From: Jacob Deva Racusin <jacob@newframeworks.com>
Sent: Thursday, September 19, 2024 1:24 PM
To: Betsy Ames
Cc: STRETCHCODE (ENE); Michael Rossi; Andy Buccino
Subject: Re: Embodied Carbon MA Code Comments Meeting

From: Betsy Ames <betsy@nehers.org>
Sent: Thursday, September 19, 2024 11:38 AM
To: STRETCHCODE (ENE)
Cc: Michael Rossi; Jacob Deva Racusin; Andy Buccino
Subject: RE: Embodied Carbon MA Code Comments Meeting

Draft Stretch Code Updates Released for Public Comment

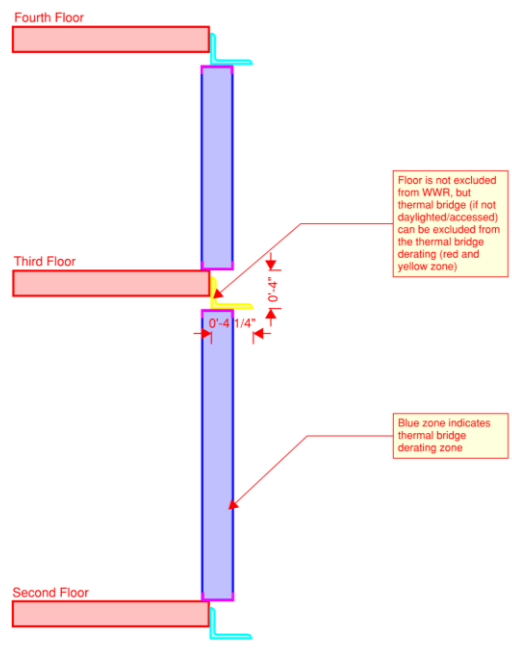
- Recommend adding clarifying language and providing diagrams in the technical guidance. See below. It is important to clarify that this language applies to existing thermal bridges that are not “exposed” or “daylighted”.

- The detail below shows an existing thermal bridge for a “Change of Use” building (from office to lab). This type of masonry veneer construction is problematic due to the existing steel angle at the floor slabs, which continues around the entire building perimeter.
